June 28, 2017

RE: **ABQ Ride Daytona Transit Facility**
Grading and Drainage Plan (Engineer's Stamp Date: 6/28/17)
Hydrology File: J09D025

Re: ABQ Ride Daytona Transit Facility
Grading and Drainage Plan
Hydrology File J09D025

SUBJECT: Daytona Transit Facility, Grading and Drainage, Hydrologic and Hydraulic Analysis, Project #5658.05

City Project No. COA 5658.05 Zone Map No. J-09-Z Sheet C-6

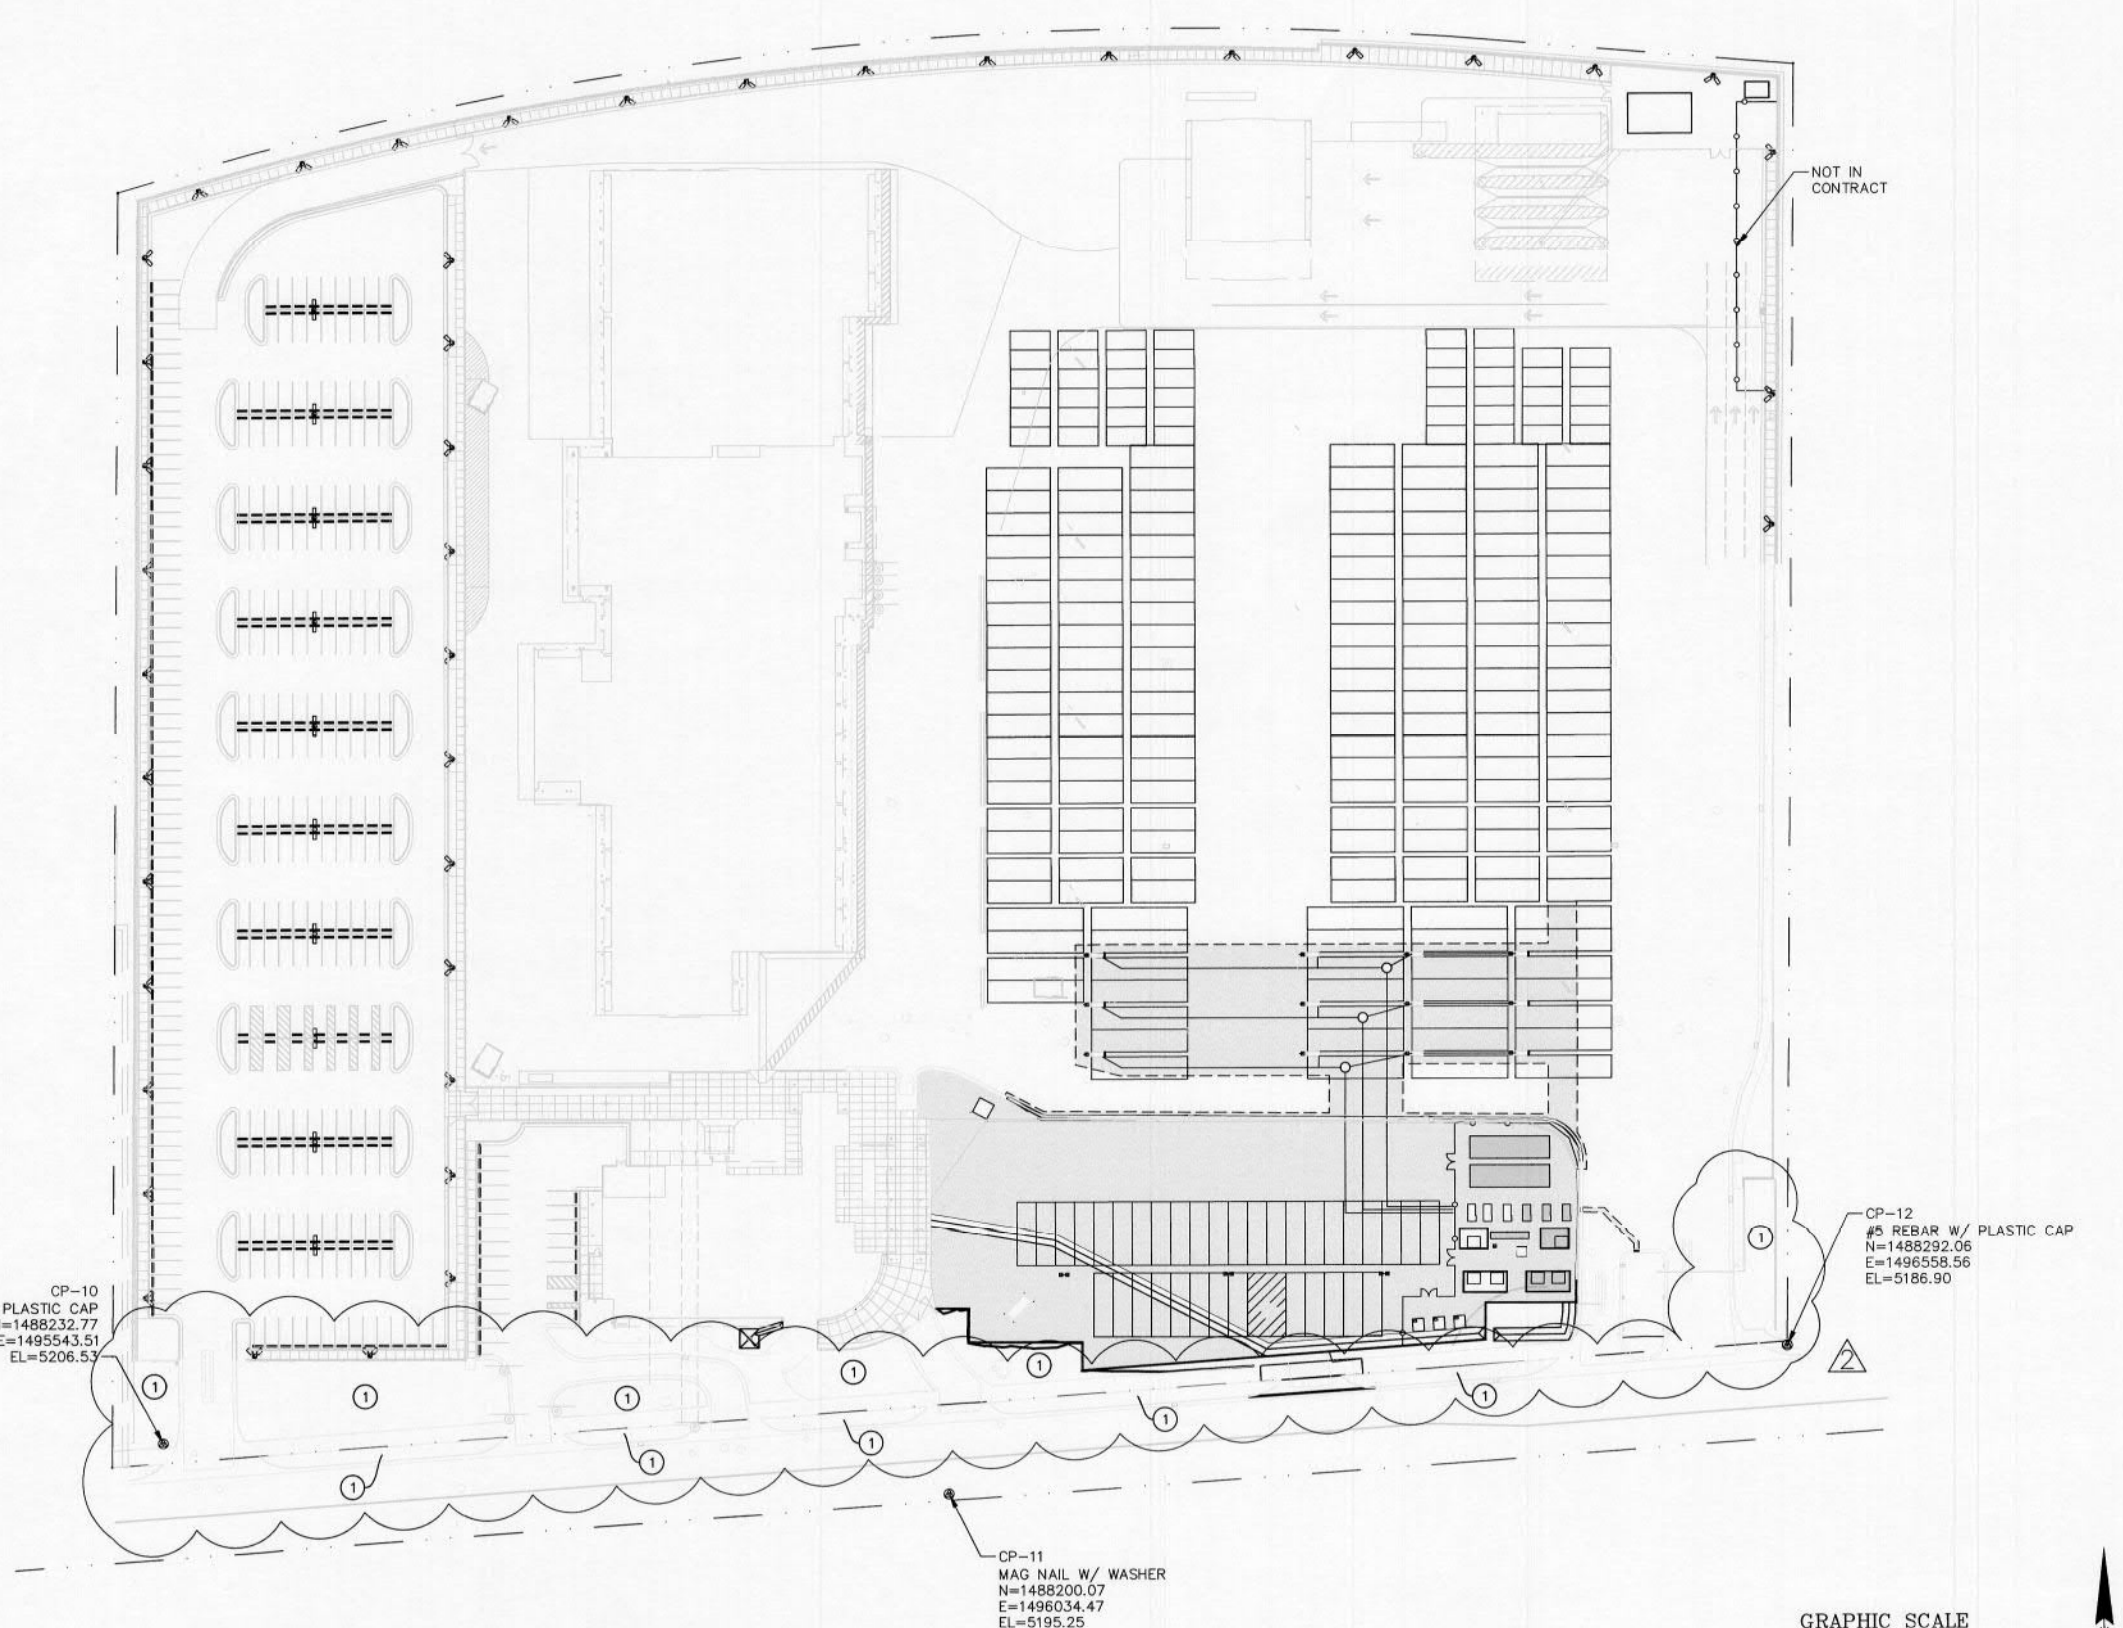
1. The depressed landscape areas are being built per the construction plans, sheet C-6, attached, and sheet C-11, which was provided with the original submittal.

CITY OF ALBUQUERQUE TRANSIT DEPARTMENT ABQ RIDE ABQ RIDE DAYTONA DESIGN	
WALL PLAN & PROFILE	
DESIGN REVIEW COMMITTEE	CITY ENGINEER APPROVAL
City Project No. 60A 5658.05	Zone Map No. J-09-Z
Sheet S1

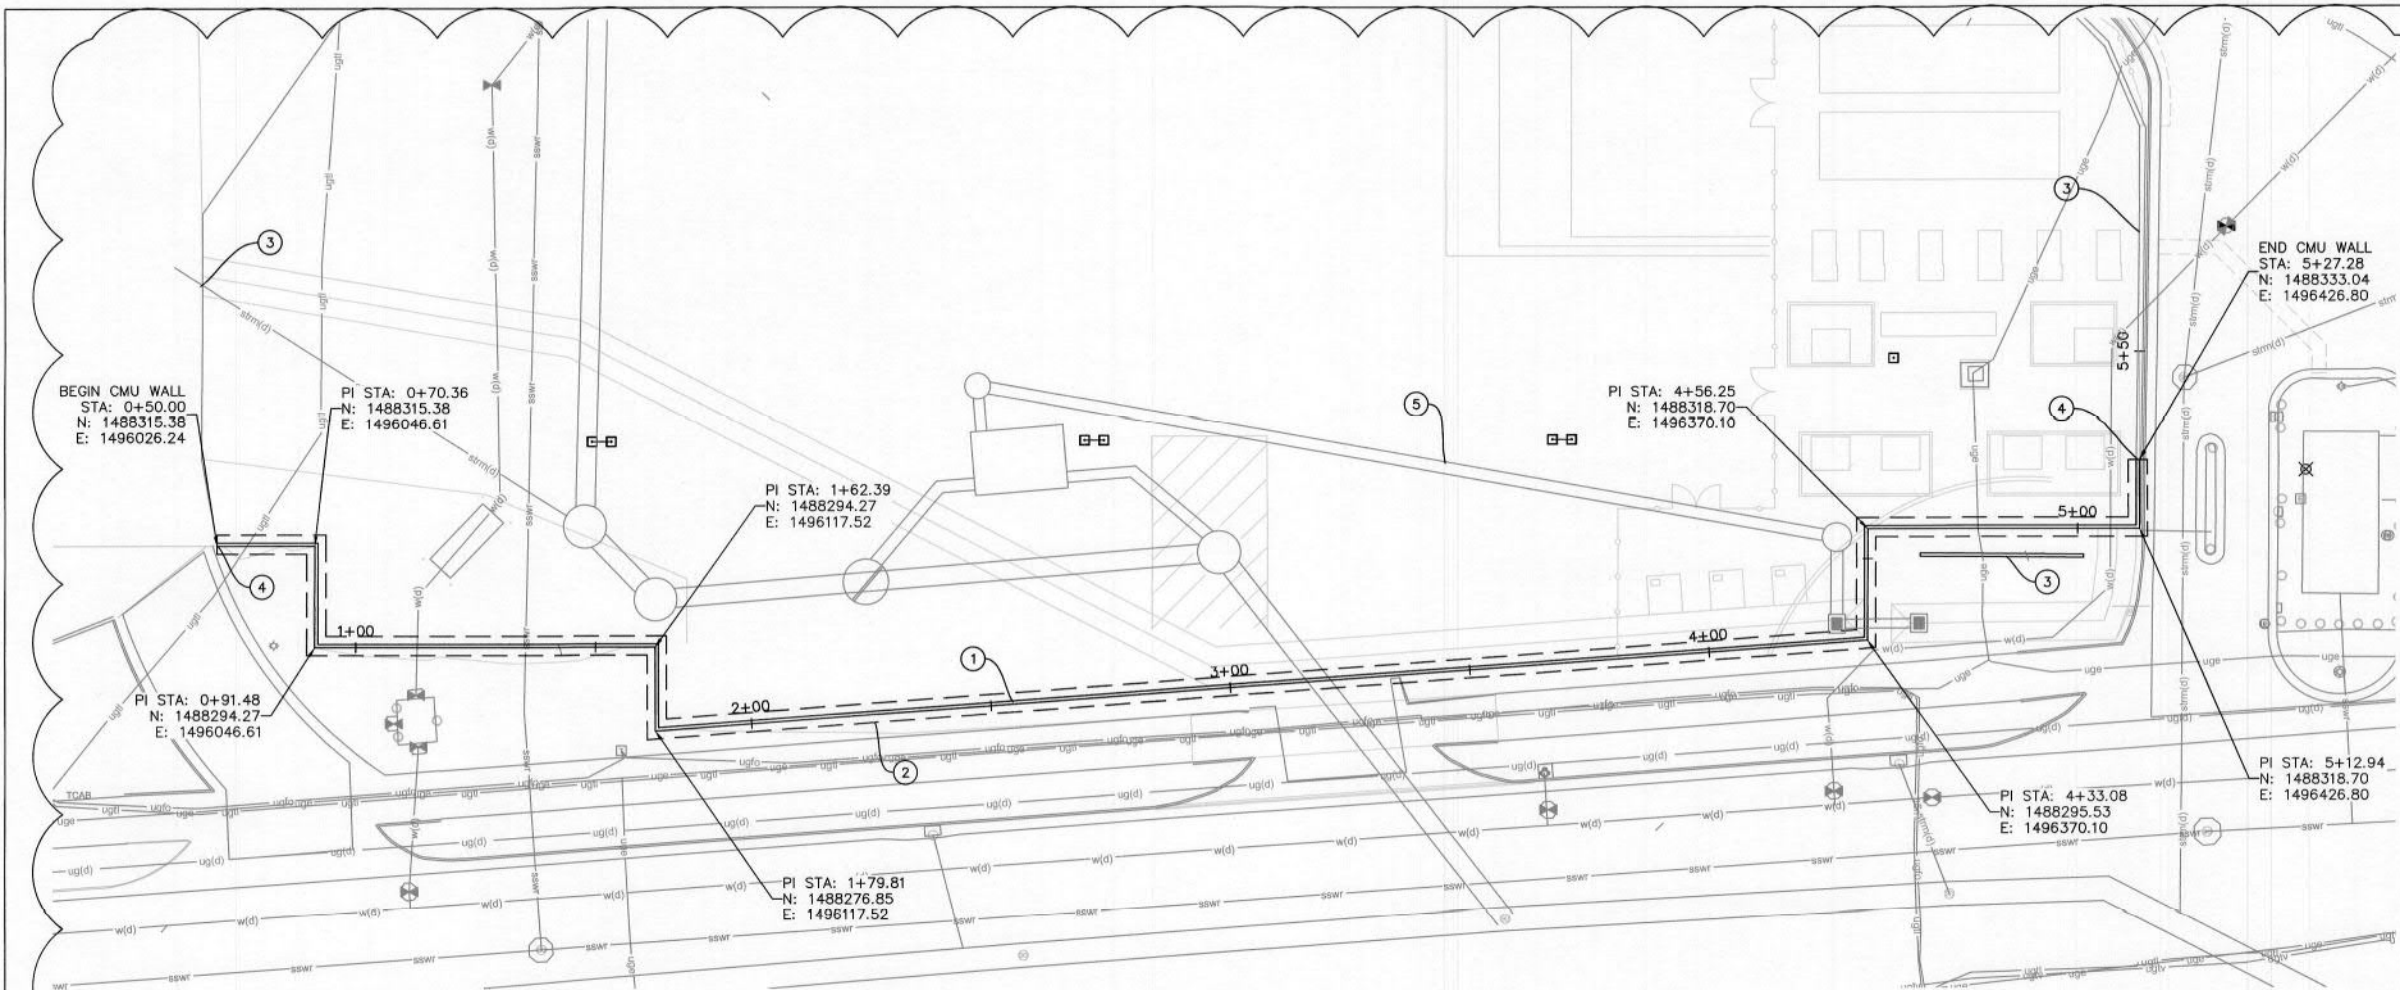
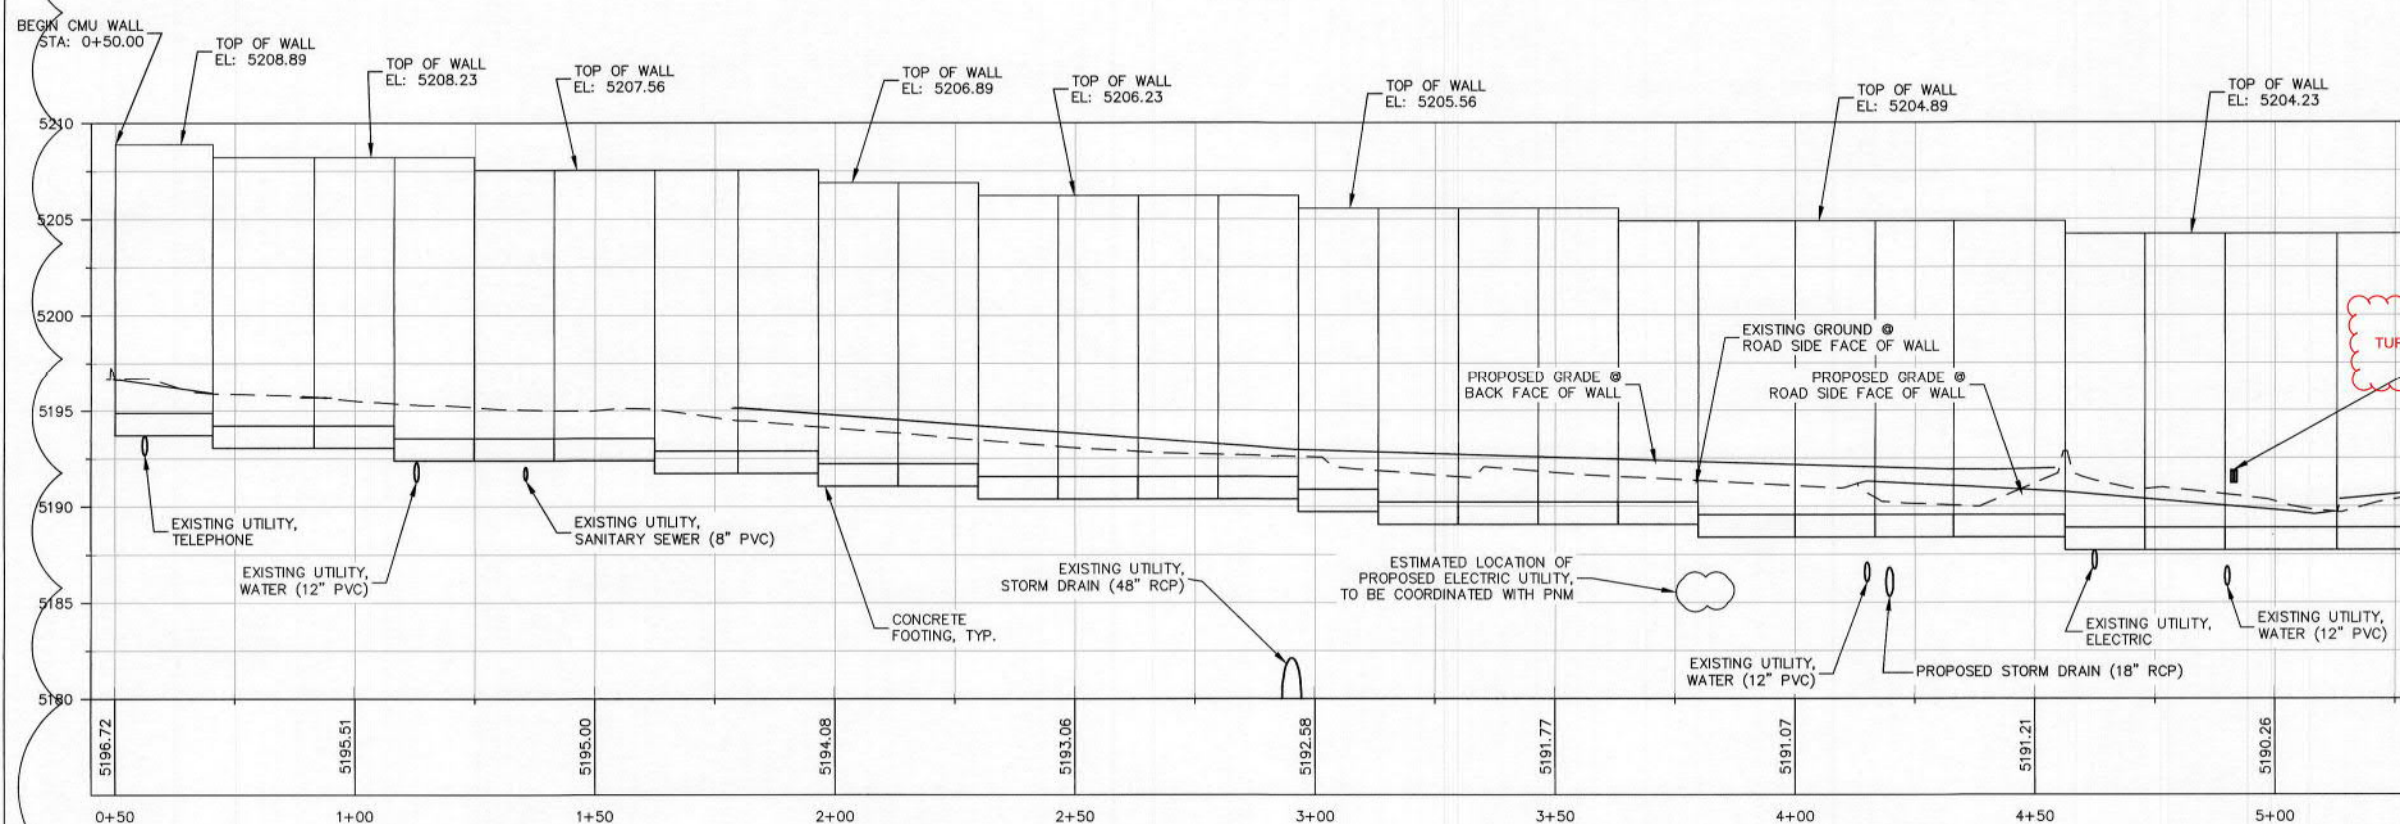
2. Wall details are included for your reference, sheets S-1 and S-4, showing turned blocks to pass drainage.
3. A memo describing the drainage analysis for the site is attached, for your review. This includes the information requested, per the City of Albuquerque DPM Chapter 22.
